PLANNING AND ZONING COMMISSION AGENDA-SPECIAL MEETING

STAFF REPORT
KETCHUM PLANNING AND ZONING COMMISSION
SPECIAL MEETING OF September 11th, 2017

PROJECT: Northwood Commercial Mixed - Use

REQUEST: Pre-Application Design Review approval for a new commercial mixed-use building.

ARCHITECTURAL SITE PLAN

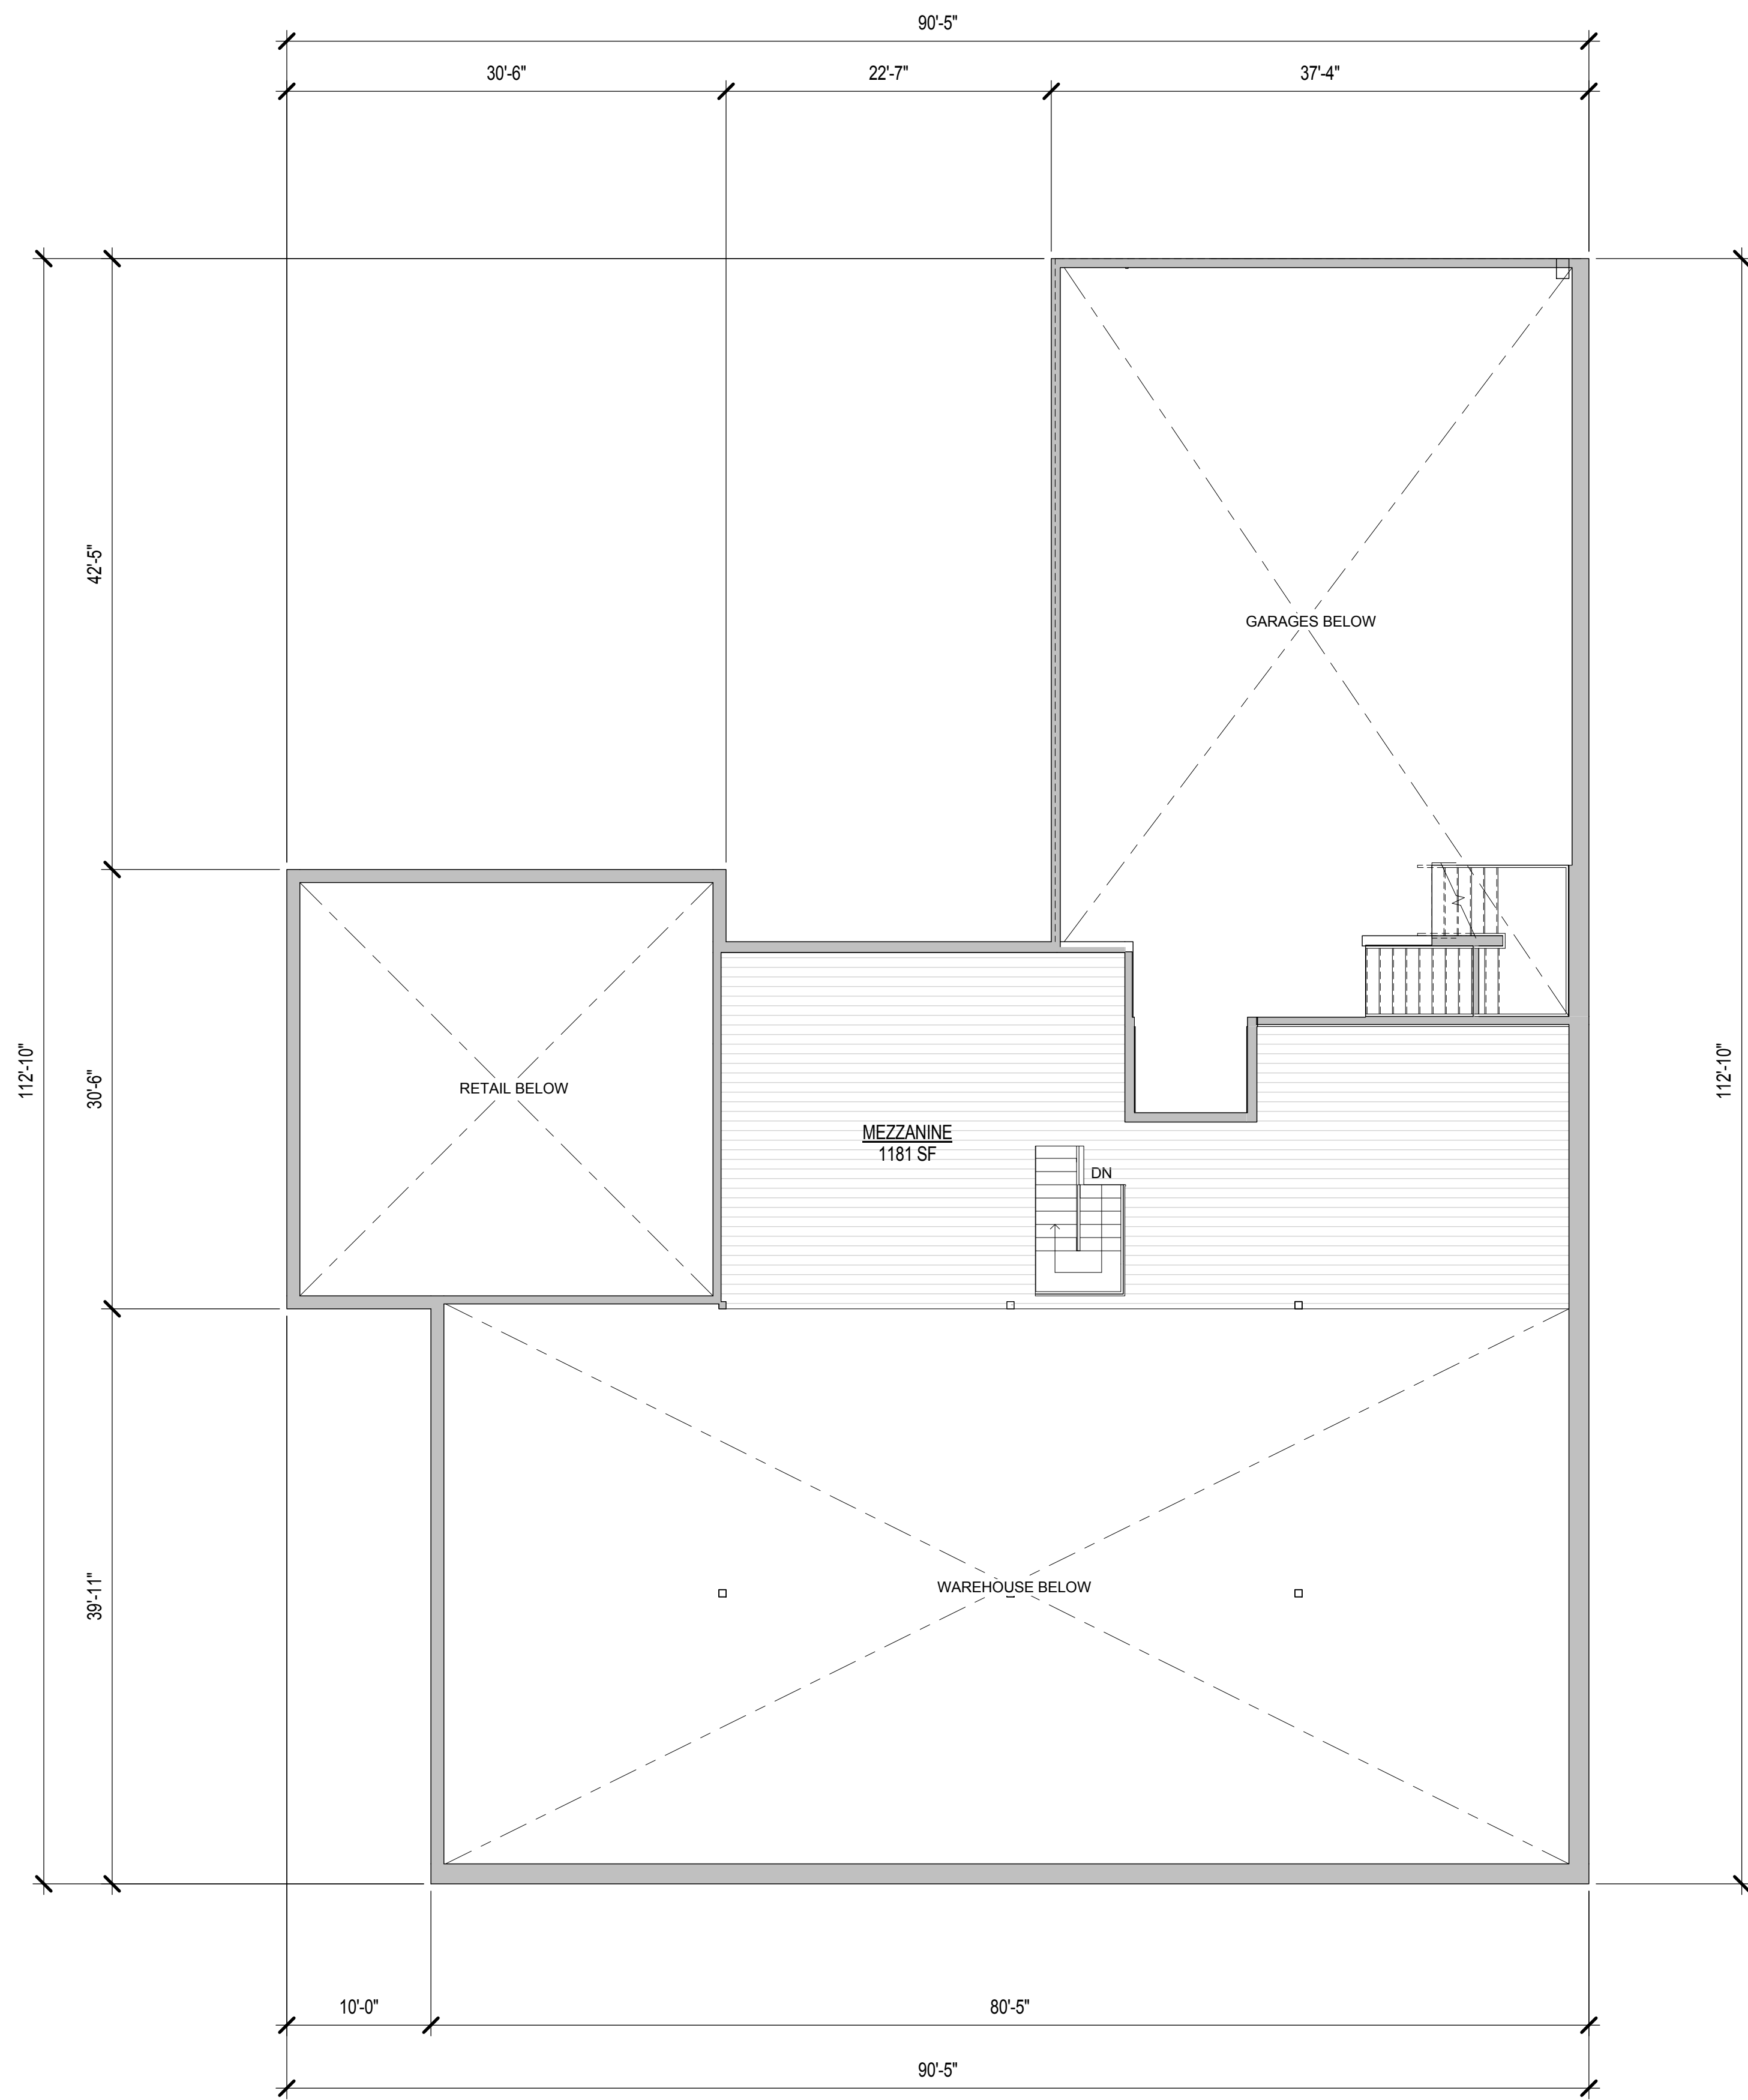
17.96.060(H)(1)	Snow storage areas shall not be less than thirty percent (30%) of the improved parking and pedestrian circulation areas.
<i>Comments</i>	<i>Snow storage will be as depicted on the architectural site plan, and will conform the City's requirements.</i>

17.96.060(H)(2)	Snow storage areas shall be provided on site.
<i>Comments</i>	<i>Snow storage will be as depicted on the architectural site plan, and will conform the City's requirements.</i>
